Groundwater Transfer Review Summary Form

Transfer/PA # T- 14860

Application: T-14860

Applicant Name: Jenck Farms, LLC

Modeled Stream Depletion: Authorized POA TILL 50225/50440 to Trask River

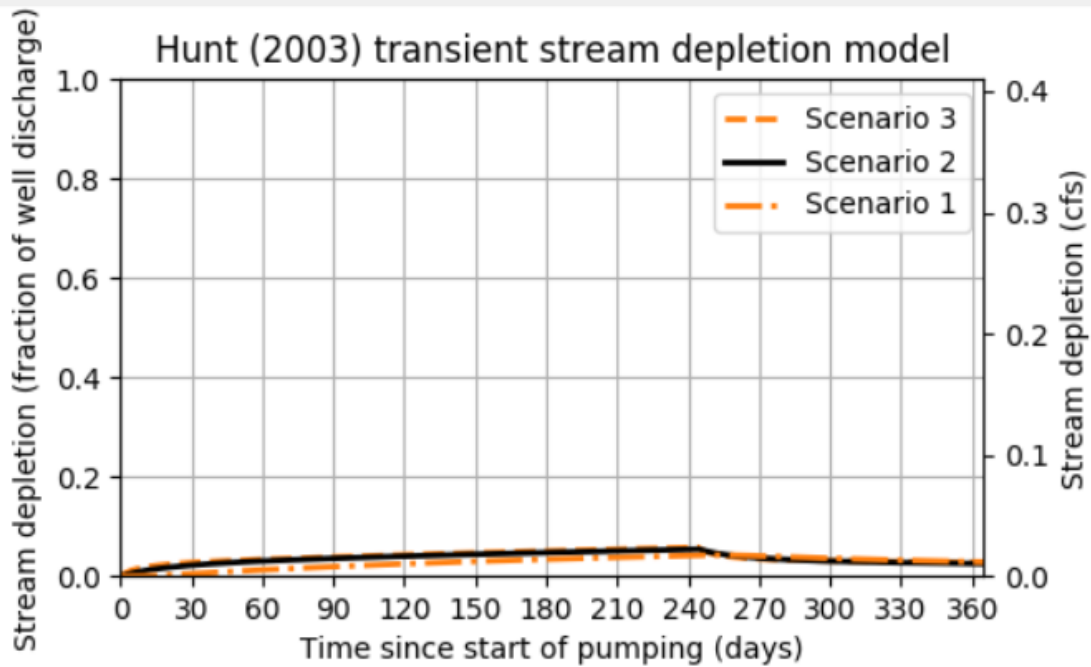
6. a) Will this proposed change, at its maximum allowed rate of use, likely result in an increase in interference with **another surface water source**?
 Yes No Comments: Authorized POA TILL 50225/50400 is located approximately 450 feet west of the Trask River. The proposed APOA would be located approximately 260 feet west of the Trask River. Based on the reduced intervening distance, the proposed change would likely increase interference with the Trask River.

- b) If yes, at its maximum allowed rate of use, what is the expected change in degree of interference with any **surface water sources** resulting from the proposed change?
Stream: Trask River Minimal Significant
Stream: _____ Minimal Significant
Provide context for minimal/significant impact: The Hunt 2003 analytical stream depletion model was used to estimate the maximum potential interference at Trask River caused by the proposed change. Model parameters are derived from nearby pumping tests and published values (Freeze and Cherry, 1979). Model results indicate that interference is expected to increase by 1 to 2%. Additionally, based on the relatively efficient hydraulic connection and tidal influence on streamflow, the potential increase of interference with surface water sources is considered minimal.
